Access Compliance Report Public Rights-of-Way (Curb Ramps)

Intersection ID: 44893 Main Street: SAMS_LN Cross Street: DABNEY_DR Location: S

ADA ID: F3EF05002DDB Ramp Type: PerpDiag Initial Pass/Fail: Fail Overall Compliance: No Severity Score: 25

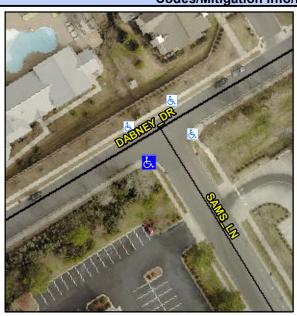
R304.2.2, R304.5.3

Compliance Description		Data	Compliance Description		Data
N/A	Ramp Length (in)	42.0	No	Ramp Slope (%)	10.2
Yes	Ramp Width (in)	48.0	No	Ramp XSlope (%)	5.8
N/A	Flare Type LT	N/A	N/A	Flare Type RT	N/A
N/A	Flare Slope LT (%)	N/A	N/A	Flare Slope RT (%)	N/A
N/A	Flare Traversable LT?	N/A	N/A	Flare Traversable RT?	N/A
N/A	Landing Length (in)	N/A	N/A	DWS Provided?	N/A
N/A	Landing Width (in)	N/A	N/A	DWS Contrast?	N/A
N/A	Landing Slope (%)	N/A	N/A	DWS Length (in)	N/A
N/A	Landing X Slope (%)	N/A	N/A	DWS Full Width?	N/A
N/A	Landing Curb? (Y/N)	N/A	N/A	DWS Offset (in)	N/A
N/A	Shared Landing?	N/A			
N/A	Gutter Ponding?	N/A	N/A	Gutter Slope (%)	N/A
N/A	Gutter Lip Ht (in)	N/A	N/A	Gutter X Slope (%)	N/A
N/A	Painted X Walk1?	No	N/A	Painted X Walk2?	No
	X Walk 1 Direction	To NE		X Walk 2 Direction	To NW
N/A	X Walk 1 Width (in)	N/A	N/A	X Walk 2 Width (in)	N/A
	X Walk 1 Slope (%)	3.2		X Walk 2 Slope (%)	0.4
	X Walk 1 X Slope (%)	4.5		X Walk 2 X Slope (%)	4.3

Remove & Replace Curb Ramp With
Two New Directional Ramps or
Equivalent.
